# Service Bulletin

Date: **28 July 2021**

Subject: **Front mudguard mounting screws tightening**

Product: **F3 (all versions) – Superverloce Euro5 (all versions) – Brutale 800 (all versions) – Dragster 800 (all versions) – Turismo Veloce (all versions)**

### Identification of the parts:

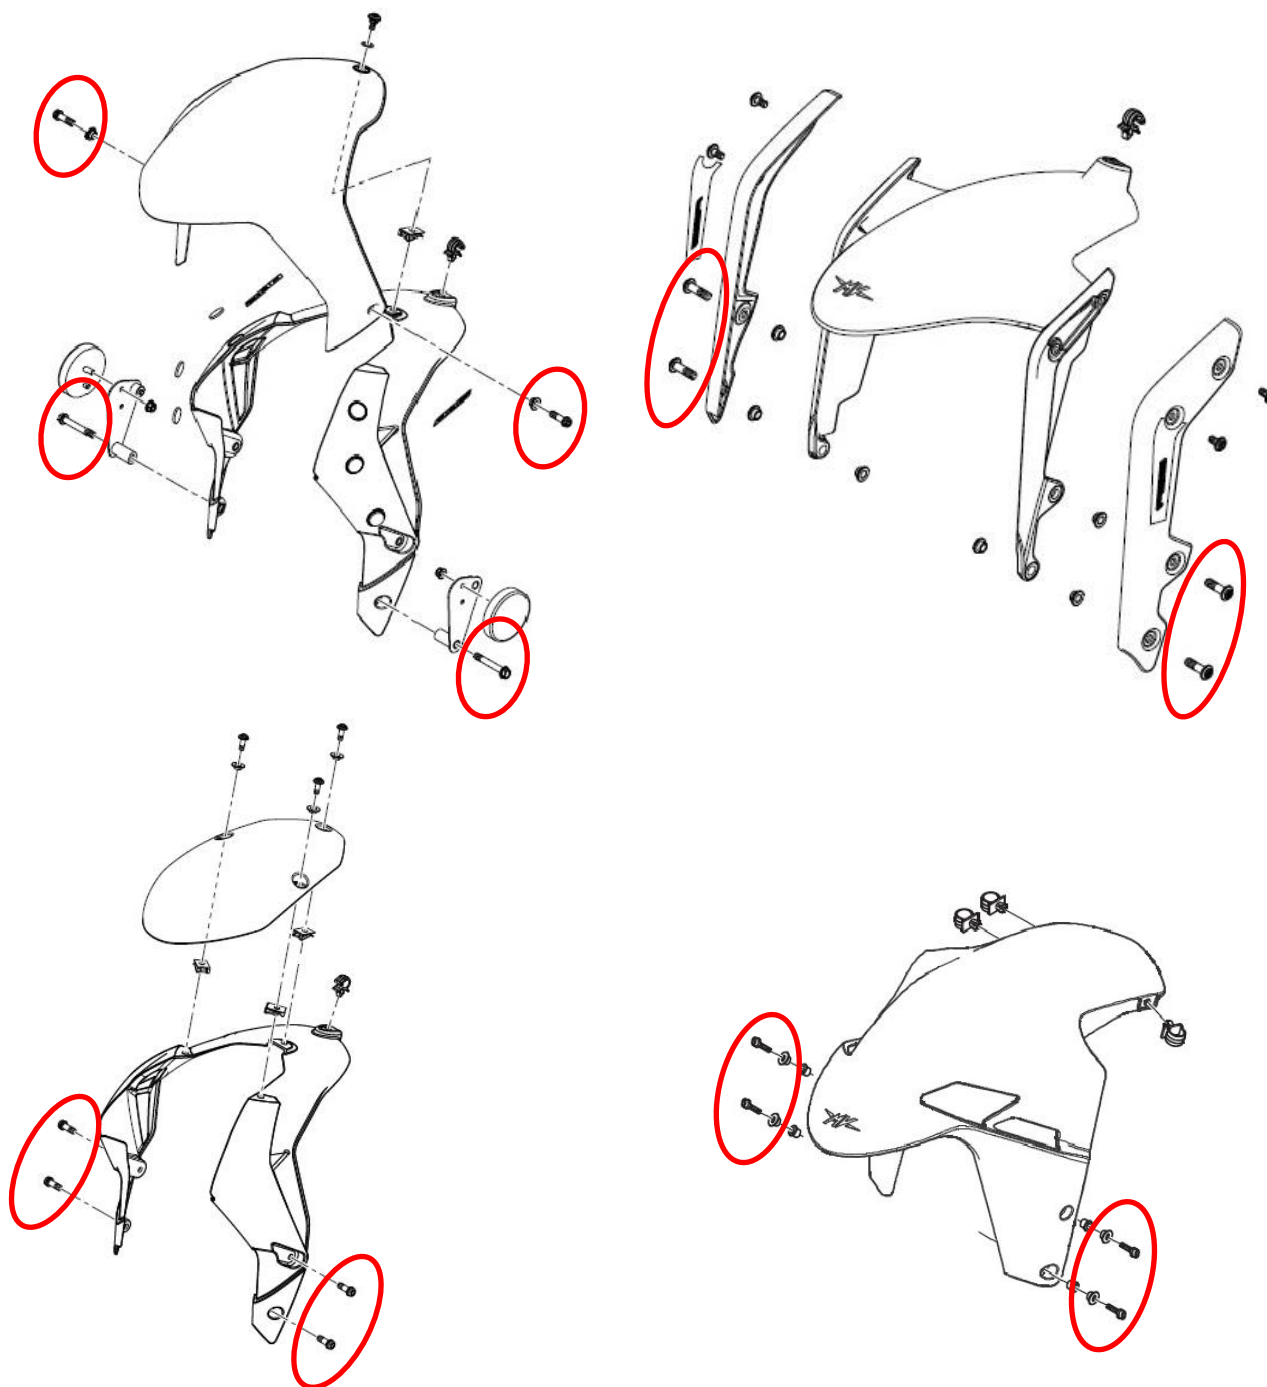
As part of the process of continuous improvement of the quality of our products, It is necessary to check the tightening of the fixing screws of the front mudguard, as it has been found that on some vehicles the fixing screws have an incorrect torque that could cause loosening and consequent malfunction or damage. It will then be necessary to modify the tightening torque by following the instructions below. We ask you to check and possibly update the bikes during the pre-delivery phase, during a maintenance service or at the first useful opportunity at your workshop.

1. Locate the fixing screws of the front mudguard
2. Tighten all fixing screws to a torque of **10 Nm**.
